G5+ Software Option Software Number: VSG111061 Part Number: CIMR-G5MXXXXF-005⁽¹⁾

This document is an addendum to Technical Manual TM4515, listing the effect of this software on the parameters in the drive and function descriptions in the manual.

Figure 1: Disturbed Speed Reference When Using the Traverse Function

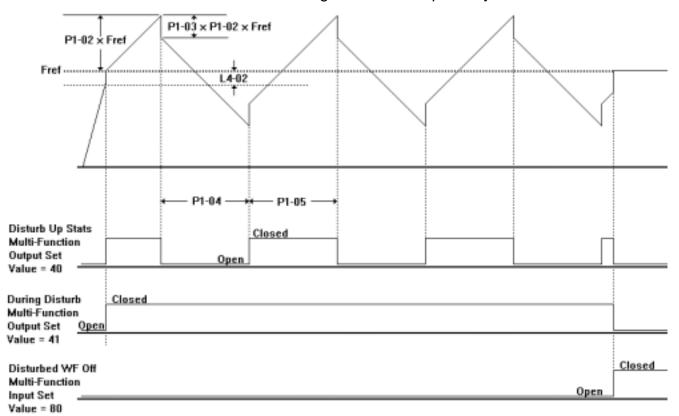
This parameter determines how much faster or slower than the set frequency reference (Fref) the actual frequency reference will be. See Figure 1.

Maximum Frequency = Fref + [**P1-02** x Fref] Minimum Frequency = Fref - [**P1-02** x Fref]

This parameter determines how much "jump" will occur in the frequency reference, and is used to compensate for the inertia of the mechanical system. See Figure 1.

Jump Distance = P1-03 x P1-02 x Fref

These parameters determine the rate at which the speed reference will change during the "disturb" operation. **P1-04** determines the decel time, and **P1-05** determines the accel time. NOTE: The selected accel/decel rates (**C1-01** through **C1-08**) are disabled during traverse operation. See Figure 1.
